**HUMER KWER HEALTH CENTER
SULAYMANIYAH, IRAQ**

SUSTAINMENT ASSESSMENT

**SIGIR PA-09-186
APRIL 20, 2010**

Figure 1. Humer Kwer Health Center project site plan
(Courtesy of GRN)

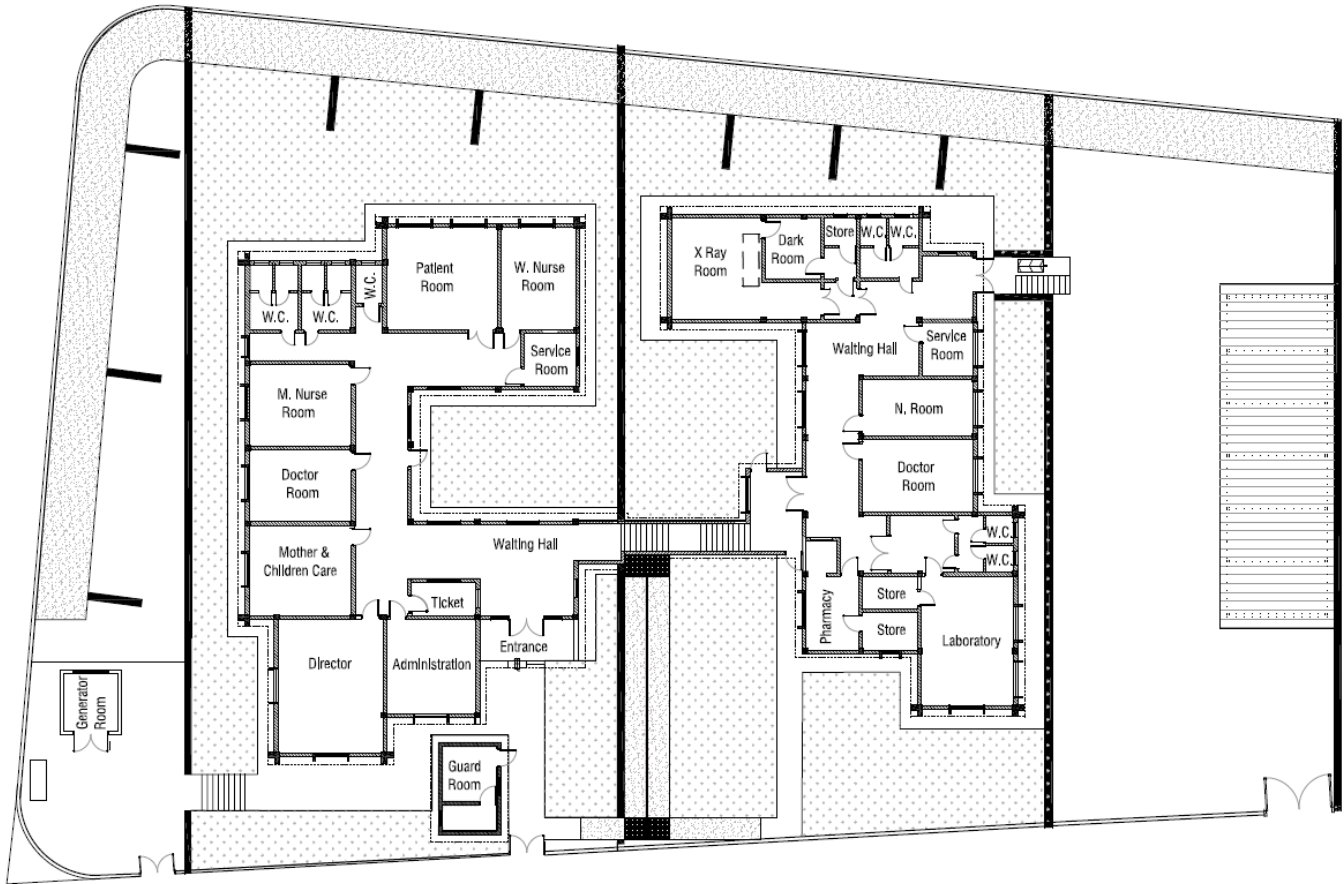
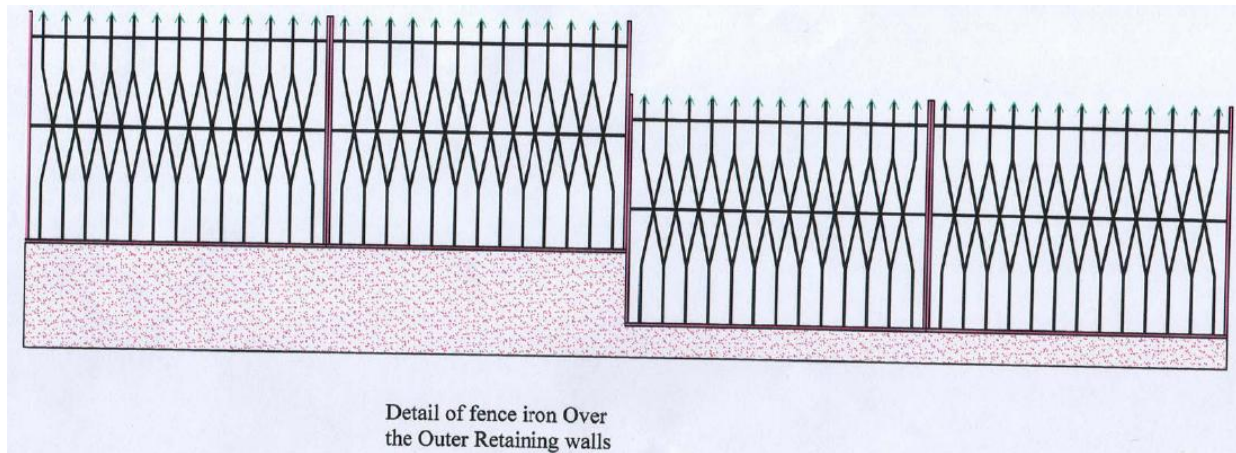
Actual construction plans differed from the conceptual site plan. The conceptual site plan was developed without the benefit of accurate topographic information for the project. Elevations shown on the conceptual site plan indicated a proposed level pad for the building and parking with only 0.20 meters of elevation change across the site. The contractor performed a topographic survey of the site to determine the actual site elevation differential. Based on the topographic survey, the actual differential in elevation across the site is approximately 18 meters. The contractor's site plan indicated the use of retaining walls to terrace the site. The building was shown on two separate levels with parking on a third level. The contractor's site plan shows the project construction within a 3,000 square meter area (Figure 1).

An exterior ramp is shown connecting the upper and lower levels of the building. The ramp is fairly long, and contains one intermediate landing. The design slope for the ramp is 10%. This is a difficult grade for handicapped individuals to traverse.
